**STATE OF TENNESSEE
DEPARTMENT OF TRANSPORTATION**

INSTRUCTIONAL BULLETIN NO. 18-07

Regarding New Section 9 - Multimodal Design

09-APR-2018 09:05 \\ag03scdw\00010\projects\Standard Drawings\Working Folder for Eugene\Draft\1 ROADWAY DESIGN STANDARDS\2 TYPICAL SECTIONS AND DESIGN CRITERIA\RD11TS8-2018XXXX.dgn

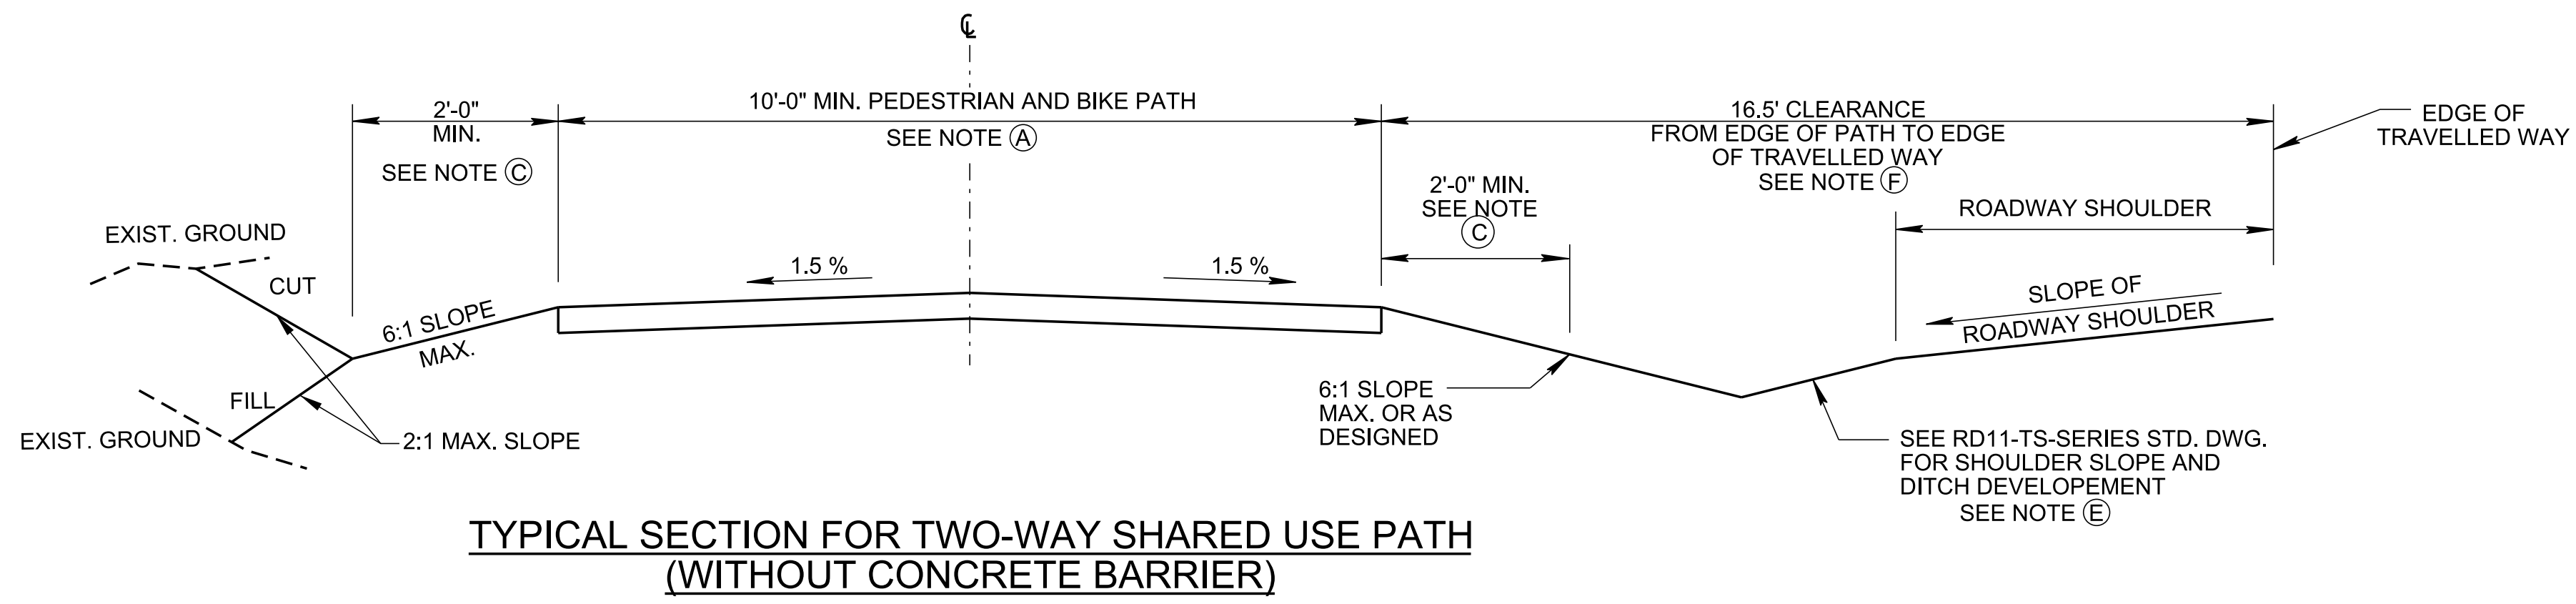
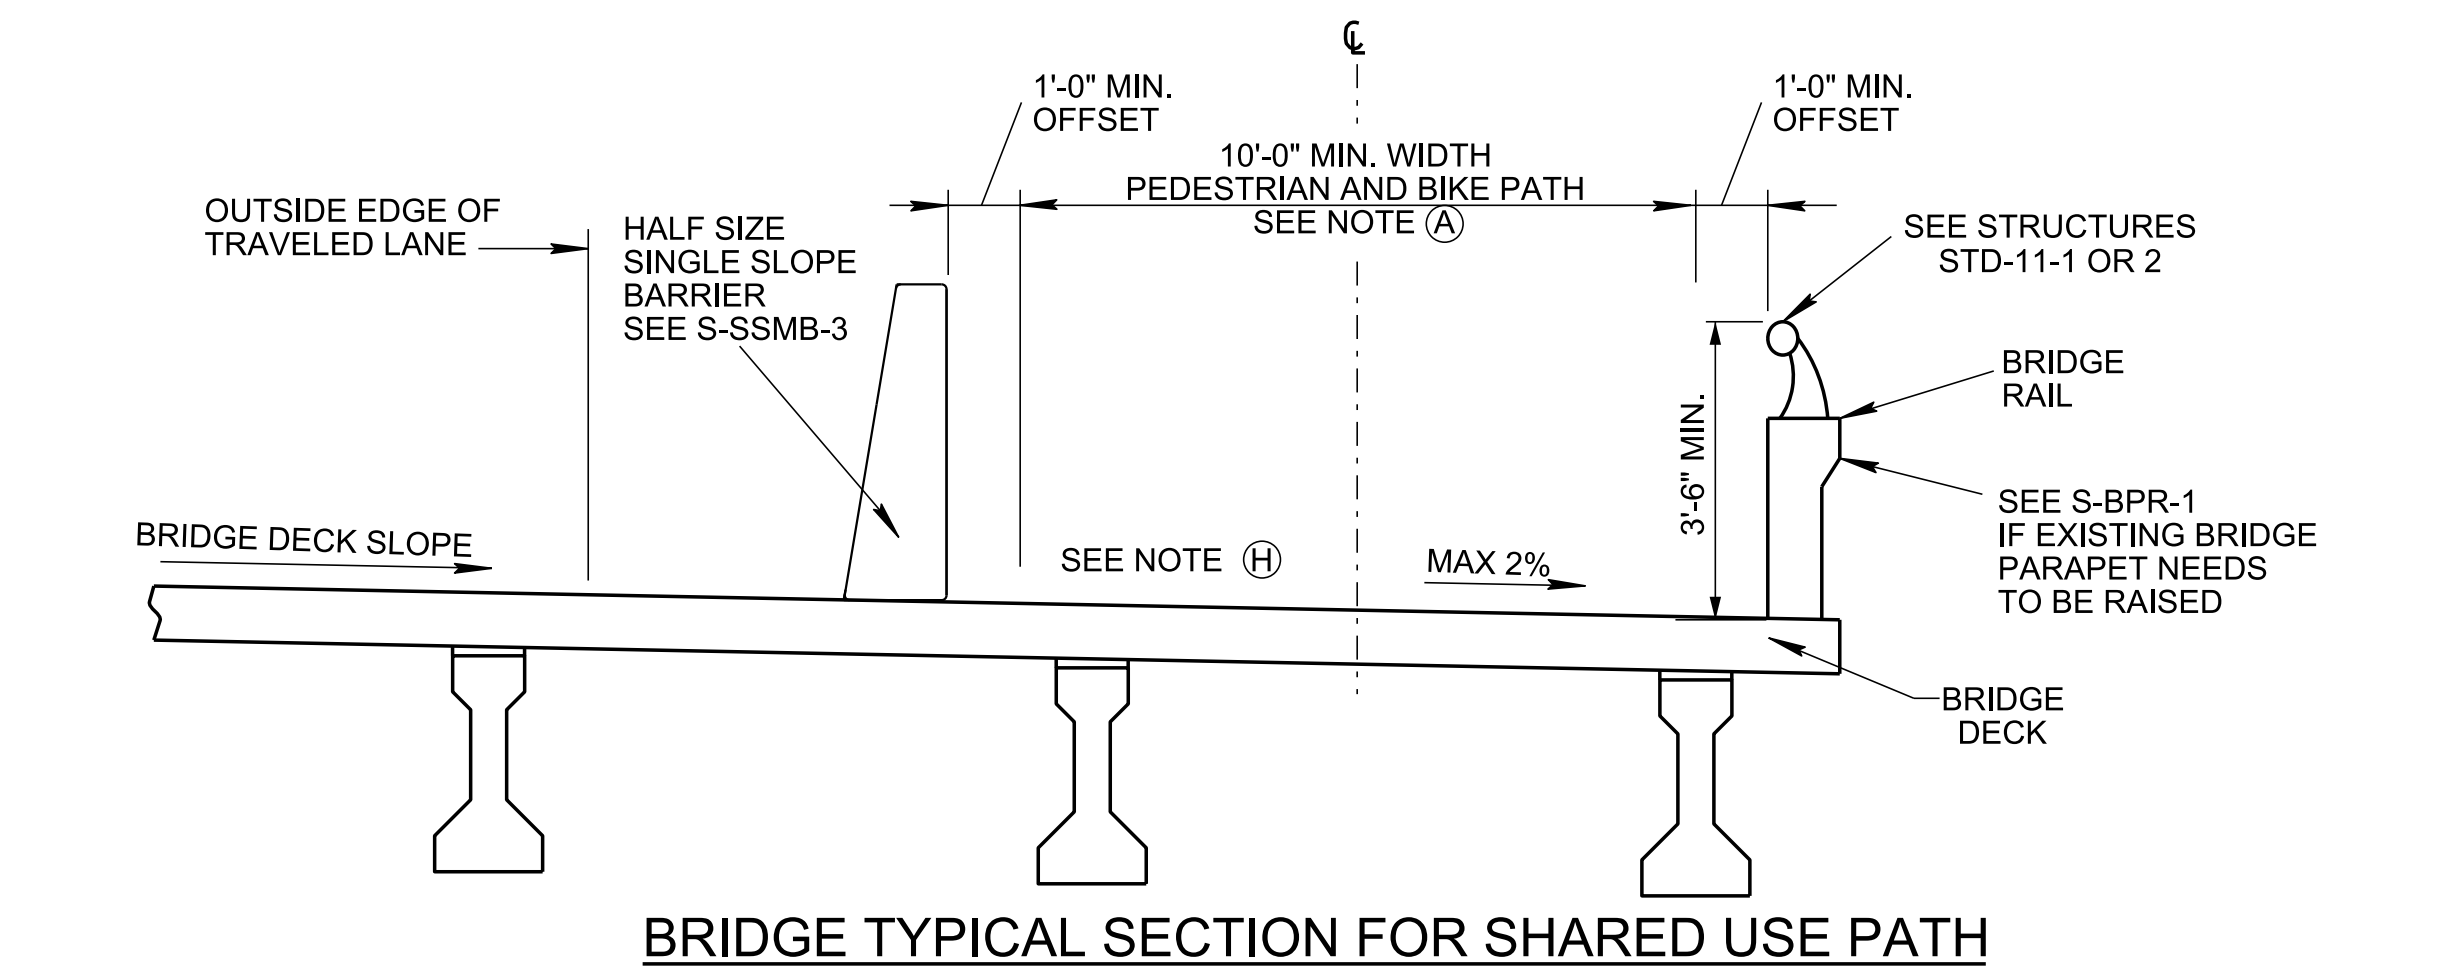
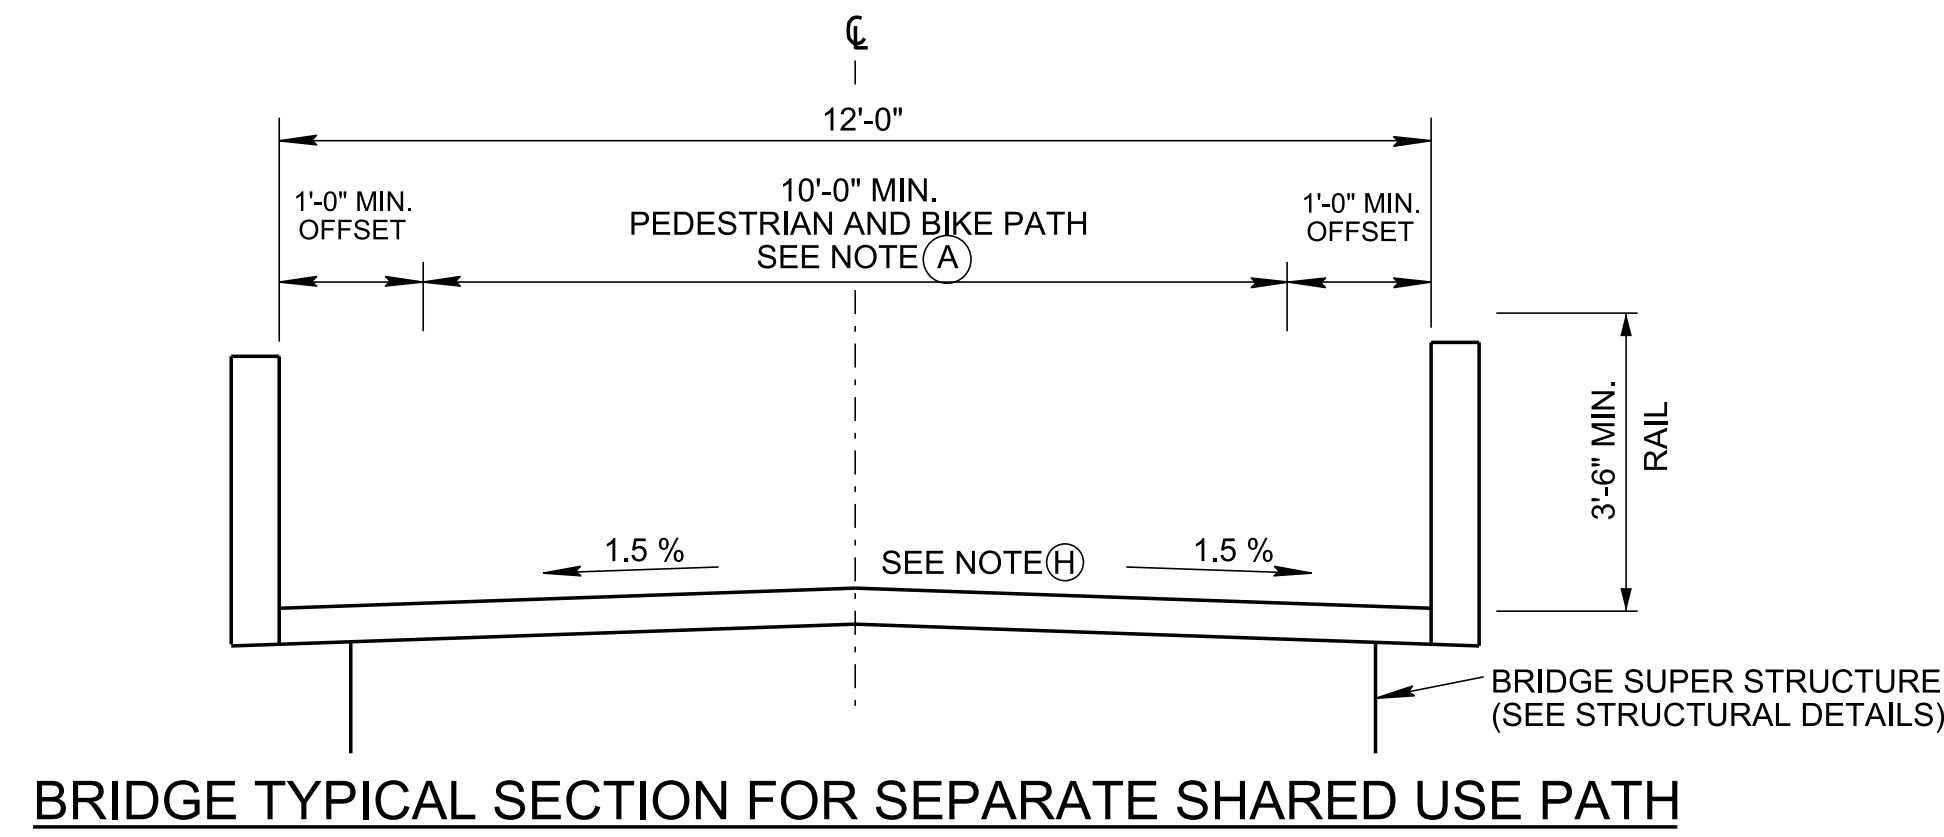
With this new section 9, three new standard drawings have been created. MM-TS-1, **Bike Accommodation Design Guidance** and MM-TS-2, **Pedestrian Facility Design Guidance** have been developed to provide guidance to designers on how to accommodate bicycle and/or pedestrians on existing facilities during 3R projects. RD11-TS-8, **Shared Use Path Typical Sections** standard drawing voids RD01-TS-8 and reduces the minimum shared use path width from 12' to 10' and added some pavement design guidance and minimum geometric design criteria.

GEOMETRIC DESIGN CRITERIA	
①	18 MPH BICYCLE DESIGN SPEED
②	PEDESTRIAN DENSITY 200 PED/HR
③	HORIZONTAL CURVE 60' MIN. RADIUS
④	VERTICAL GRADE 5% MAX.
⑤	MINIMUM PAVED PATH WIDTH 10' WITH MAX. 6:1 SLOPE, 2' WIDE, CLEAR OF OBSTRUCTIONS
⑥	MAXIMUM CROSS SLOPE 2%
